BROWNS FERRY NUCLEAR PLANT, UNIT NO. 2

AMENDMENT TO FACILITY OPERATING LICENSE

Amendment No. 75
License No. DPR-52

ATTACHMENT TO LICENSE AMENDMENT NO. 75

FIGURE 6.1-1

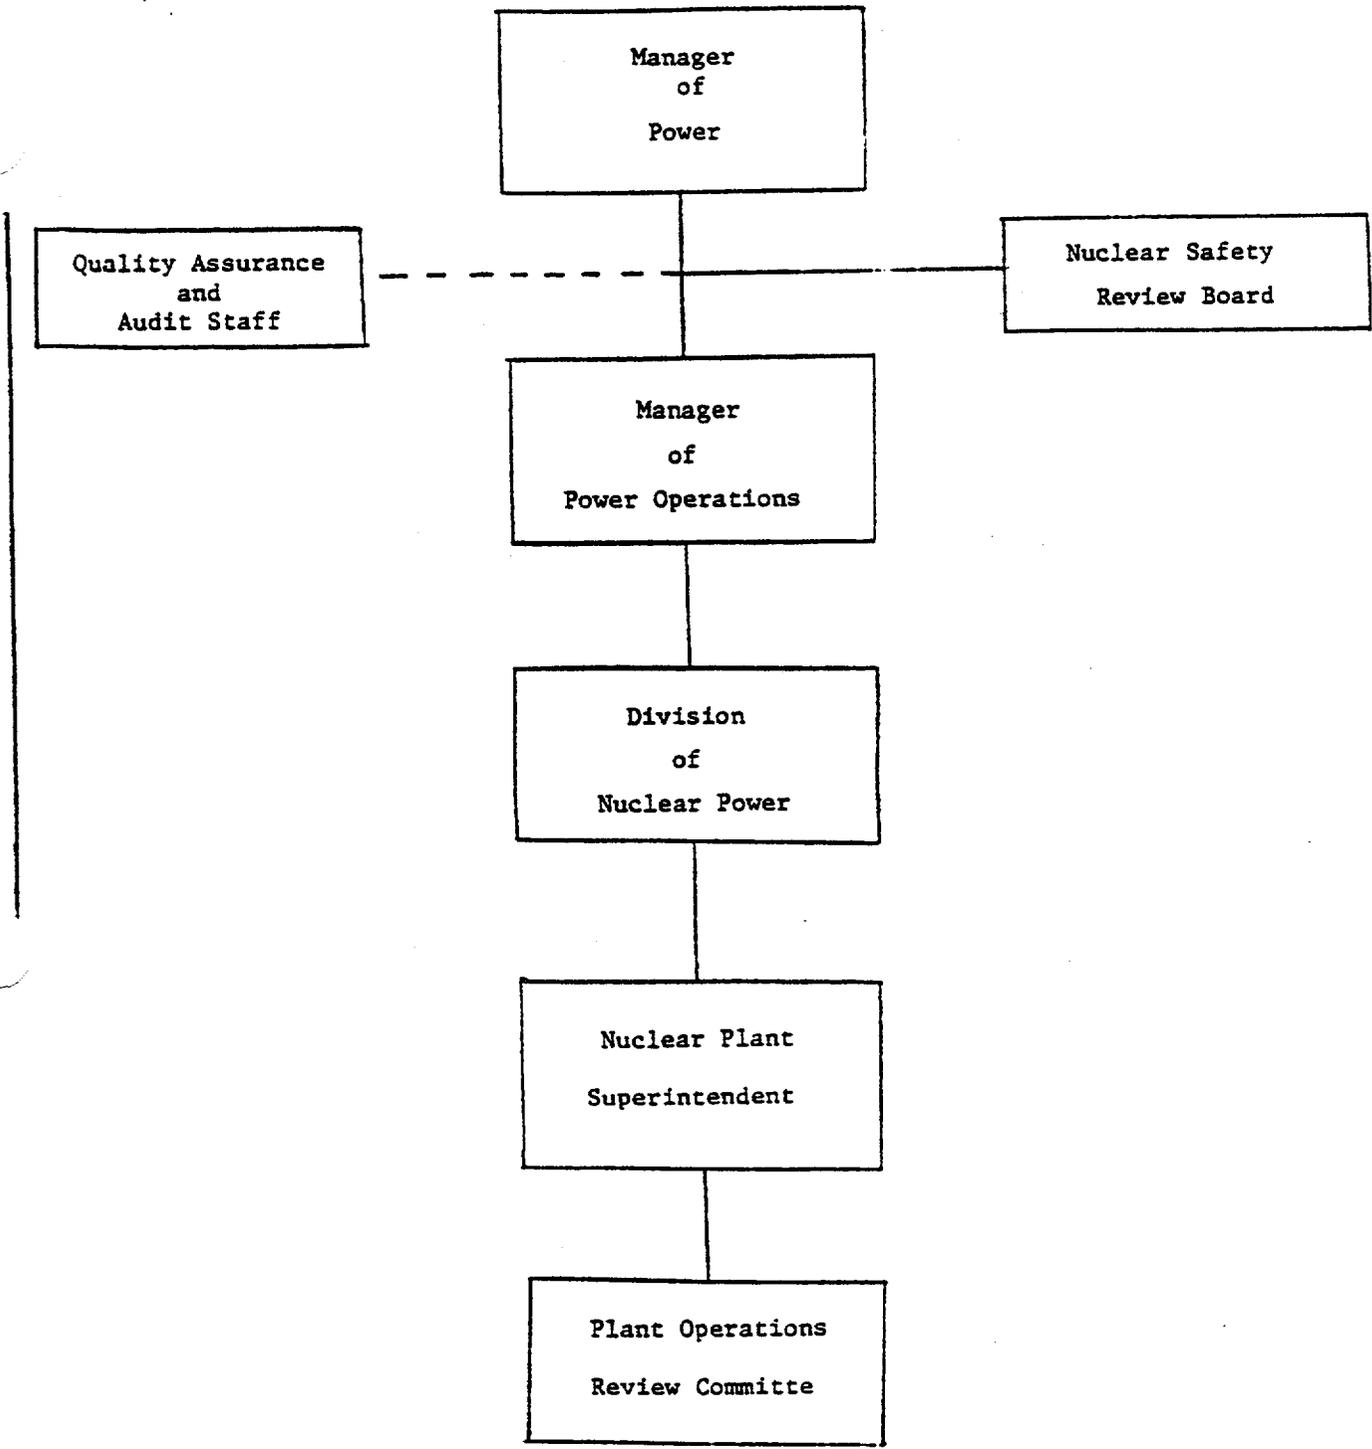
- a. Reflect that TVA's Division of Power Production has been separated into two divisions--the Division of Nuclear Power and the Division of Fossil and Hydro Branch. The former Nuclear Generation Branch is now the Division of Nuclear Power.

force on site can approach 3,000 people. Initially, BFNP had one assistant plant superintendent. In January 1981 a second assistant plant superintendent was added. Recently, a third assistant plant superintendent was authorized. Section 6.1 of the Technical Specifications is being revised to reflect this change. One assistant superintendent will be responsible for engineering and operations, another will be responsible for maintenance, and the third is responsible for health physics, safety, security, training and administrative services. The health physics organization is placed under the Health and Safety Services, Assistant Plant Superintendent. Thus, the Health Physics Supervisor reports to an assistant superintendent and is independent from plant operations. This is in accordance with the recommendations of Regulatory Guide 8.8, "Information Relevant to Ensuring that Occupational Radiation Exposure at Nuclear Power Stations Will Be As Low As Is Reasonably Achievable" and NUREG-0731, "Criteria for Utility Management and Technical Competence" and is acceptable. The quality assurance supervisor still reports directly to the plant superintendent; there is no change in this area.
